AGENDA
OCTOBER 6, 2026
LAVON CITY COUNCIL
CITY HALL, 120 SCHOOL ROAD, LAVON, TEXAS
REGULAR MEETING
6:30 PM

B. Approve the final plat of the Nicholson Ranch Phase 2A Addition consisting of 187 residential lots and 4 common area lots on 37.761 acres in the Drury Anglin Survey, Abstract No. 2, a part of Collin County MUD No. 6 west of FM 2755 on Nicholson Ranch Trail in the extraterritorial jurisdiction of the City of Lavon, Collin County, Texas, (CCAD Parcel 2919101).

Re: ***Nicholson Ranch Phase 2A Subdivision – 187 Lots, 37.761 Acres***
Initial Plan Submittal Review

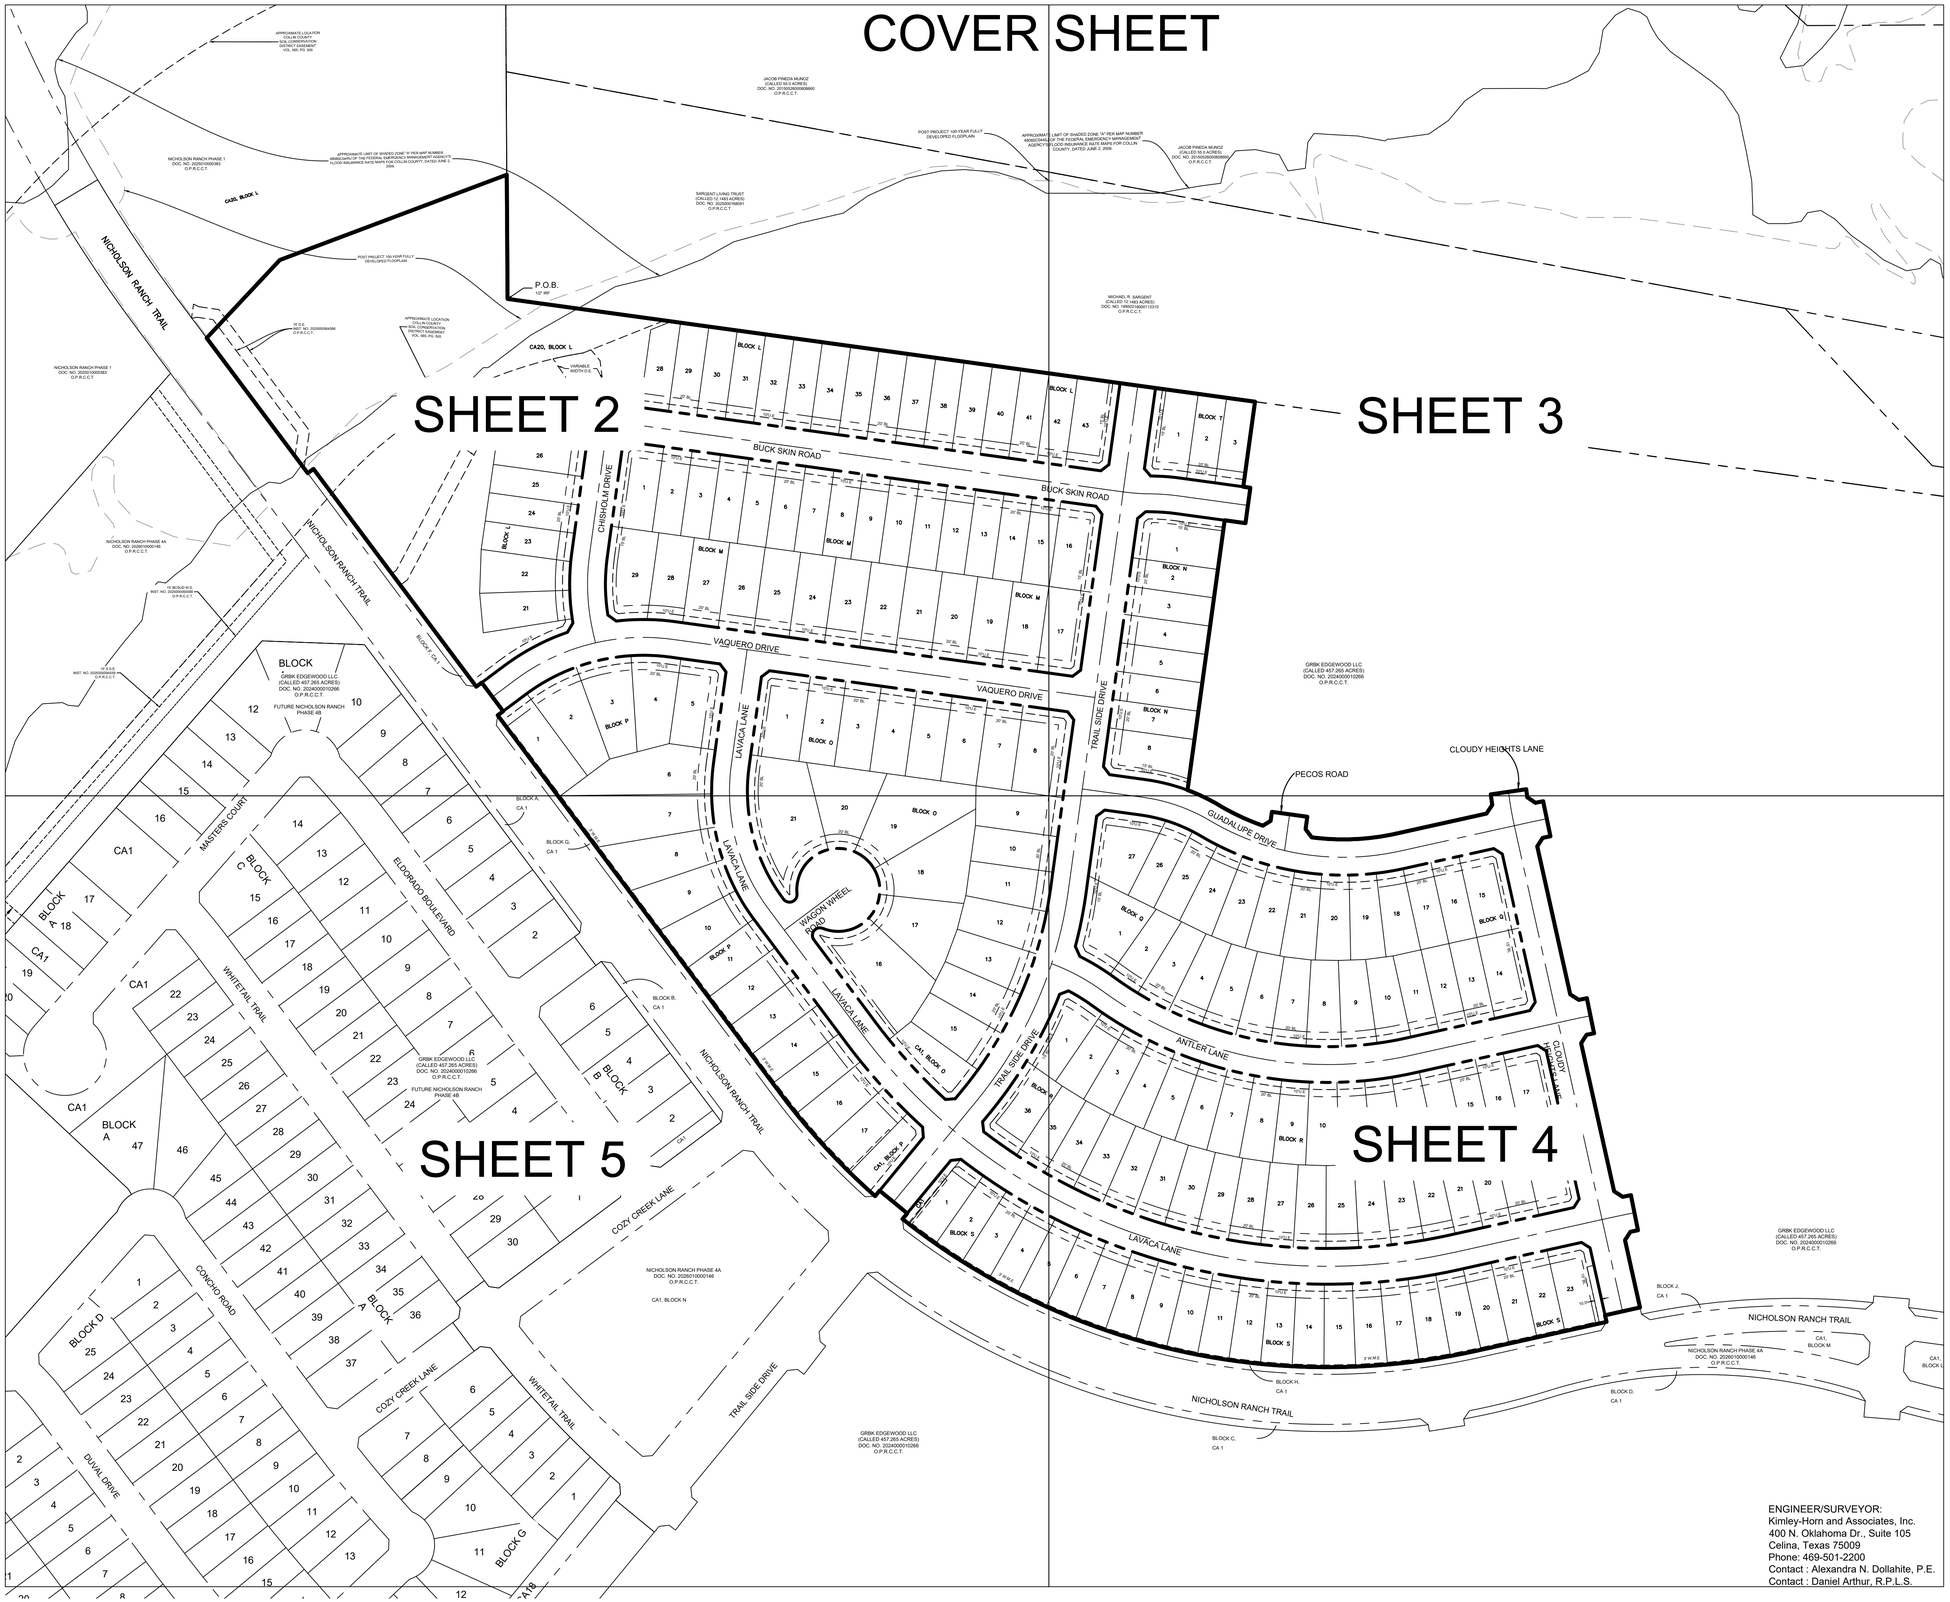
The approved preliminary plat included a street stub at the northeast corner of Phase 2B extending toward the adjacent Sargent property. During final design, grading constraints associated with existing topography, property line tie-ins, and adjacent TxDOT right-of-way were identified. These conditions limit the functionality of the originally preliminary platted street stub for future connectivity. Coordination has been initiated with the adjacent property owner, Michael
Sargent, regarding proposed improvements in this area.

- Proposed Phase 2B Modification
    - Relocate the street stub approximately 275 LF west, remaining within Phase 2B
      - Introduce knuckle geometry to improve alignment and future connectivity
      - Maintain compliance with applicable block length requirements
    - This modification results in the removal of two (2) residential lots within Phase 2B.

- Phase 2A Lot Yield Adjustment
    - Add a short block of residential lots within Phase 2A to make developer whole for the two lot drop In Phase 2B as well as adding an additional five lots to keep a balanced look, as opposed to only two lots that would visually stand out.
    - This adjustment adds seven (7) residential lots within Phase 2A. (two from Phase 2B and five new lots)

Revised Lot Summary
Previous Total Lot Count: 1,635 lots
Proposed Total Lot Count: 1,640 lots
Net Change: +5 lots overall

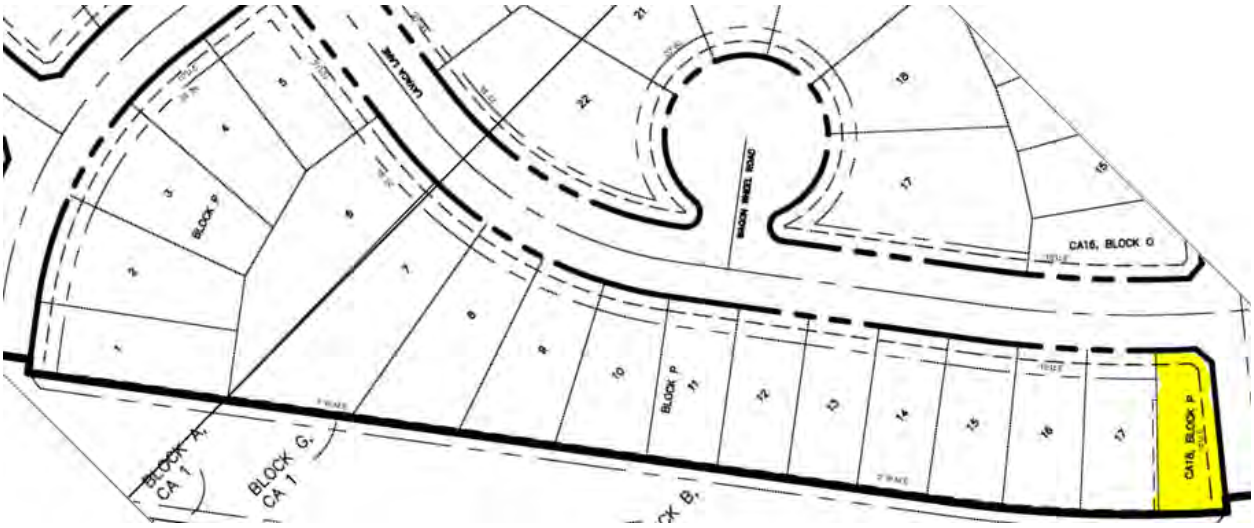
3. Revise the Final Plat to relabel CA16, Block O to CA1, Block O. Relabel the remaining lots in Block O accordingly.

Response: Plat revised as requested.

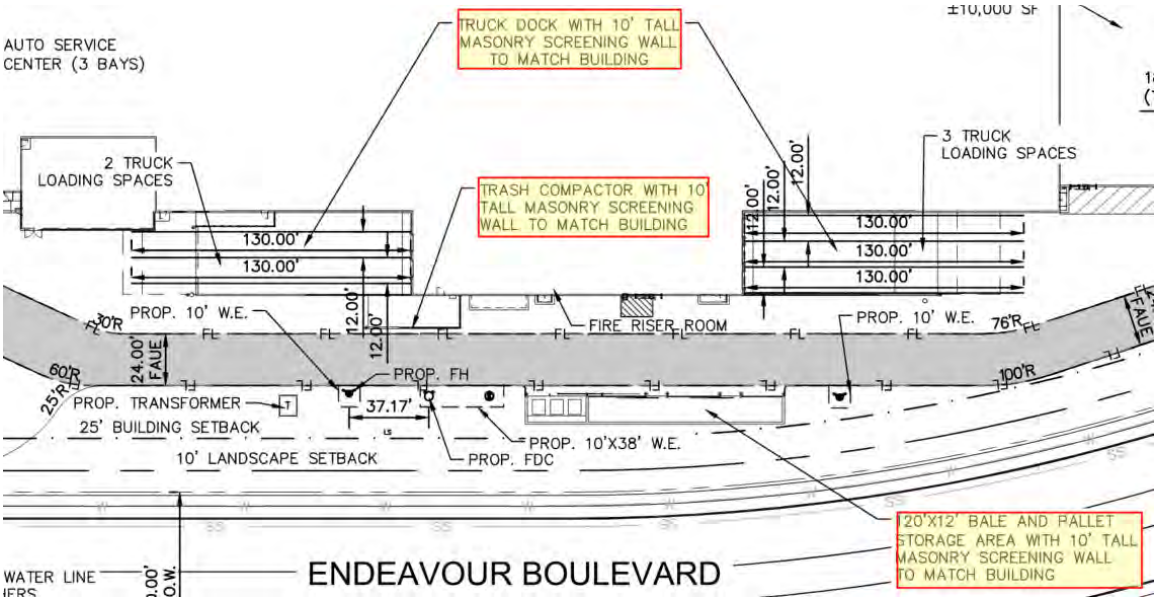
2. Revise the Site Plan to show 6-foot sidewalks along Endeavor Blvd and Grand Heritage. See screenshots below.
